GARFIELD COUNTY
COMMUNITY DEVELOPMENT

LAND USE CHANGE PERMIT APPLICATION FORM

Description of Project: TRAILER REMOVED 5-7-18. EXCAVATION TO BEGIN ON 5-9-18. BUILD FULL CELLER + 28'X56', 2 CAR GARAGE ON ONE END. ADU ON OTHER END. MODULAR HOUSE ON TOP.

JANUSZ EXEMPTION PLAT
 A PARCEL OF LAND SITUATED IN, SEC. 27, T. 6 S., R. 89 W. OF THE 6TH P.M.,
 COUNTY OF GARFIELD, STATE OF COLORADO

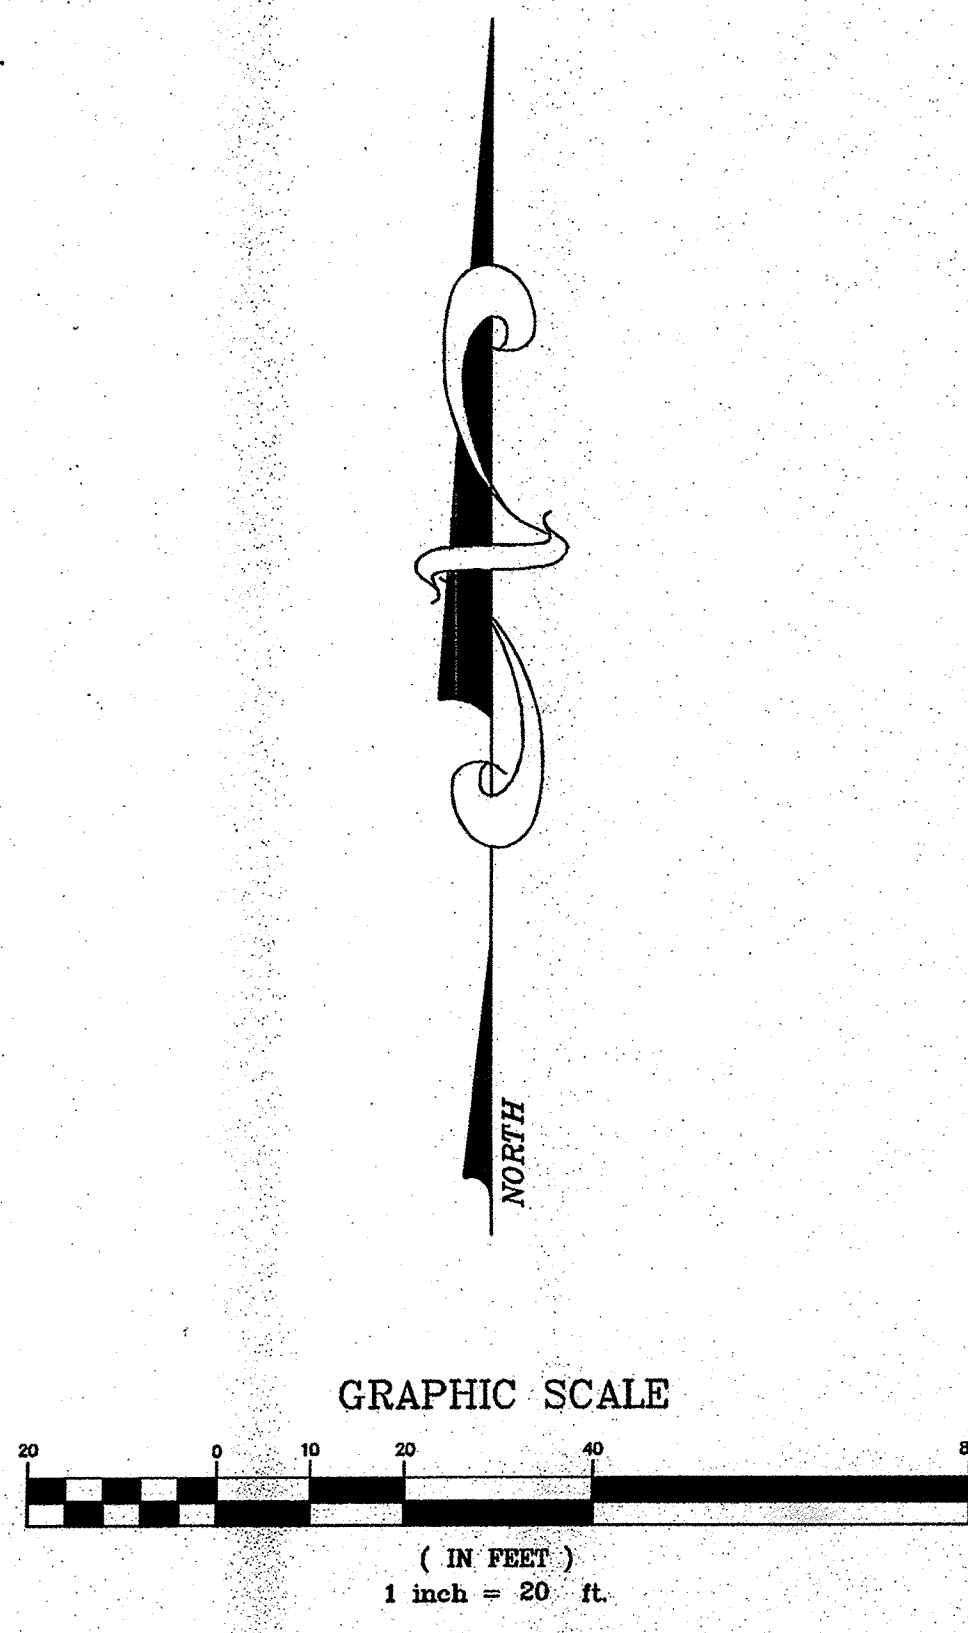
2. The Site Plan from 2009 shows a shed in the front yard setback. Please indicate whether or not that shed has been moved or provide a demonstration that the shed complies with required building setbacks. *SHED WILL BE REMOVED*
